National Highways Planning Response (NHPR 25-01) Formal Recommendation to an Application for Planning Permission

Council's Reference: AWDM/0233/26

Location: 113 Upper Brighton Road Worthing West Sussex BN14 9JD

Proposal: Secondary vehicular access to create in out driveway, new brick wall with piers

(Source: DMRB)

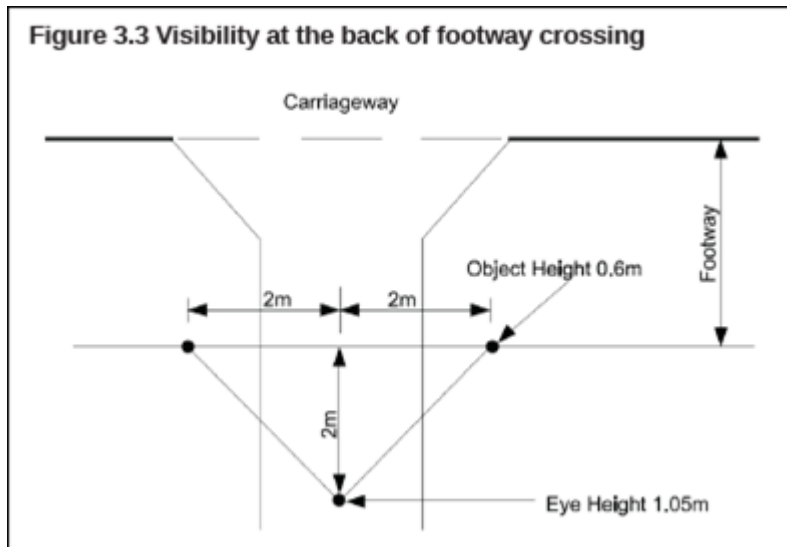
The proposed scheme shows truncated visibility splays of 4.5m x-distance and a 65m y-distance.

As the A27 is part of the SRN, visibility splays measured from the edge of carriageway must be in accordance with the standards in the Design Manual for Roads and Bridges. **The applicant will need to provide visibility splays which are required to be shown in full as per DMRB CD 123 to ensure that the visibility splays are clear of obstructions.**

Clause 3.3 of DMRB CD 123 states that “where a direct access crosses a footway, a visibility splay shall be provided in accordance with Figure 3.3”. Figure 3.3 is shown below. A clear visibility splay measured from a point 2m from the rear of the footway, in each direction for 2m shall be provided.

- **An access design compliant with DMRB CD 123.** Any Departures must be justified and approved through National Highways' standard procedures.
- **Scaled drawings showing DMRB-compliant visibility splays and the proposed access geometry.**
- **Swept paths for the largest anticipated vehicle, demonstrating safe access and egress in forward gear.**
- **A Walking, Cycling and Horse-riding Assessment and Review (WCHAR) will be required in accordance with DMRB GG 142, or an exemption note will need to be submitted.**
- **A Stage 1 Road Safety Audit which will need to be satisfactorily completed in accordance with DMRB GG 119.**
